Product Change Notification

Date Issued :	May 29, 2024	PCN Number :	515360
Reason for Change :	Capacity change or tool replacement		
Description of Change :	This notification is to inform you that Molex Lincoln Nebraska is adding capacity tooling impacting the product in the attached list. There will be no changes to the Fit, Form, or Function of the product when compared the current tooling.		
Reason for Short Notice :	Capacity Increase		
Assessment of Change :	Dimension analysis		
Planned Implementation Date :	September 20, 2024		
Customer Sample Availability Date:	August 28, 2024		
Last date to request Samples by Customer :	August 09, 2024		
Please note if Samples are not requested as per Customer Samples Request date, it may take additional 4-6 weeks to arrange Samples.			
Traceability Code Markings / Date :	Product made after planned implementation date can contain the change

MINI-FIT Foam-In-Place (FIP) 45776 Panel Mount Plug Housings

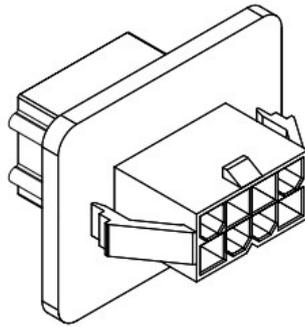
- To address increasing demand, Molex Lincoln Nebraska is adding capacity tooling to support Mini-Fit FIP series 45776
 - New capacity tooling is exact replica of existing

- There is NO impact to Fit, Form or Function
